Serial: NPD-NRC-2013-002
February 21, 2013

**LEVY NUCLEAR PLANT, UNITS 1 AND 2
DOCKET NOS. 52-029 AND 52-030
VOLUNTARY SUBMITTAL FOR COL APPLICATION PART 11 – ENCLOSURES –
ALIGNMENT OF LEVY QAPD WITH DUKE ENERGY CORPORATE QAPD AND UPDATE TO
LEVY REQUEST FOR ADDITIONAL INFORMATION LETTER NO. 010 RELATED TO QAPD**

**Duke Energy Quality Assurance Topical Report for
10 CFR Part 52 Licenses
NGGM-PM-0033**

Revision 6

Figure II.1-1

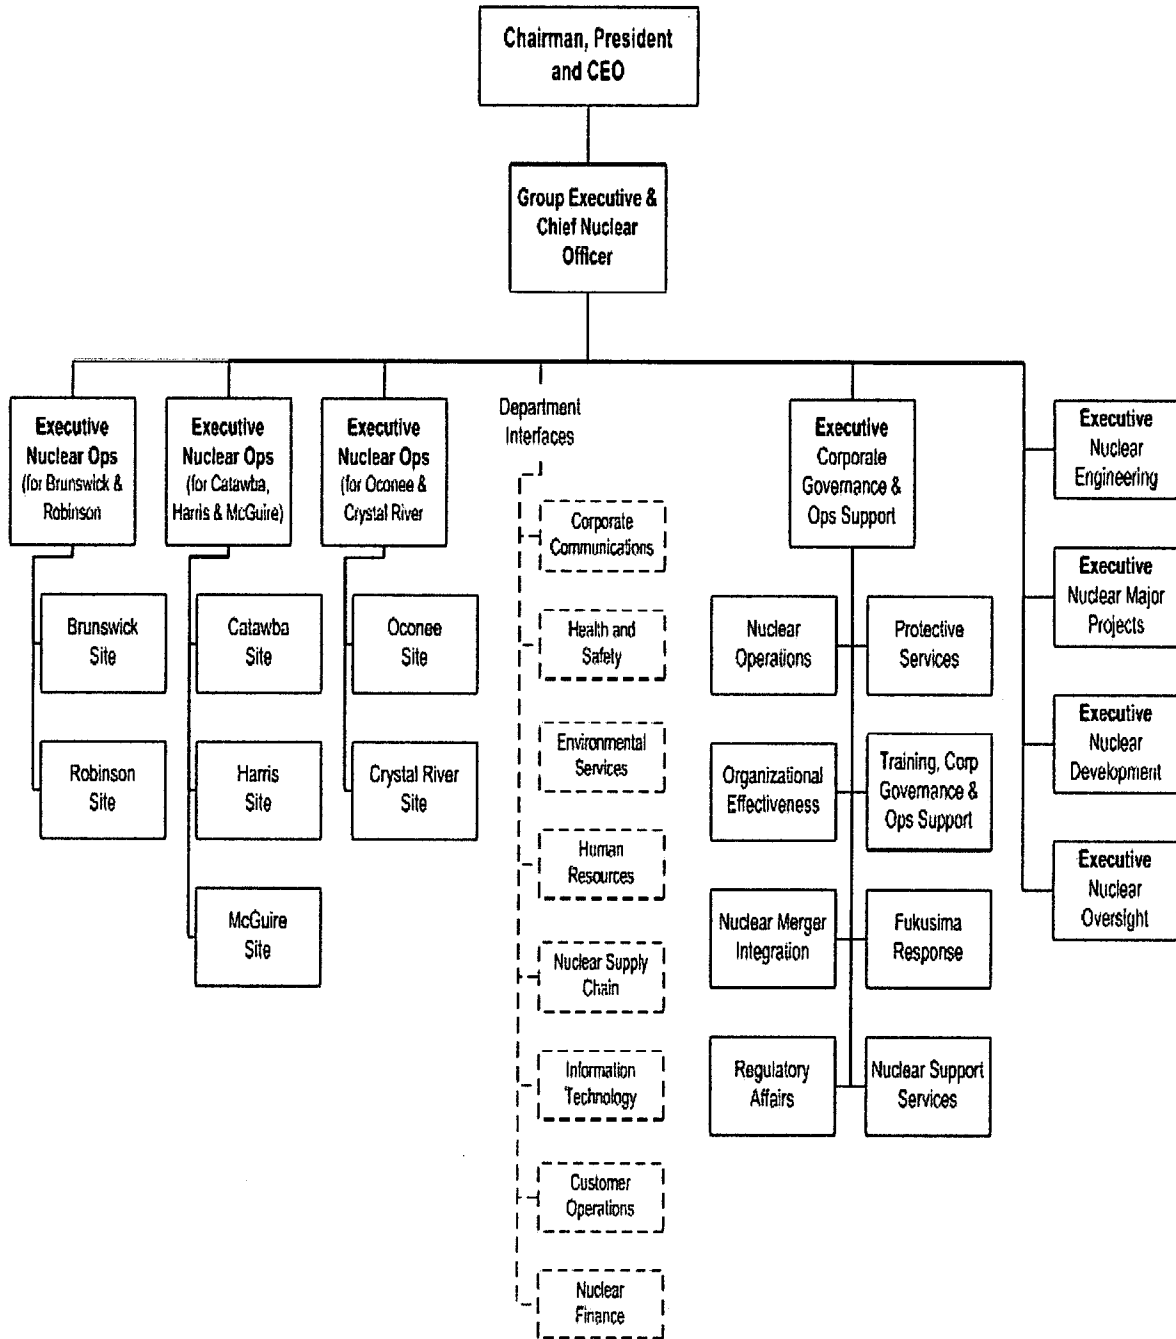
- Revised Figures II.1-1, II.1-2, and II.1-3 to reflect revised corporate, operational phase and construction phase organizations and alignments.
- Part II Sections 2 through 18 made changes to be consistent with standard approved language in NEI 06-14A rev 7 dated August 2010.
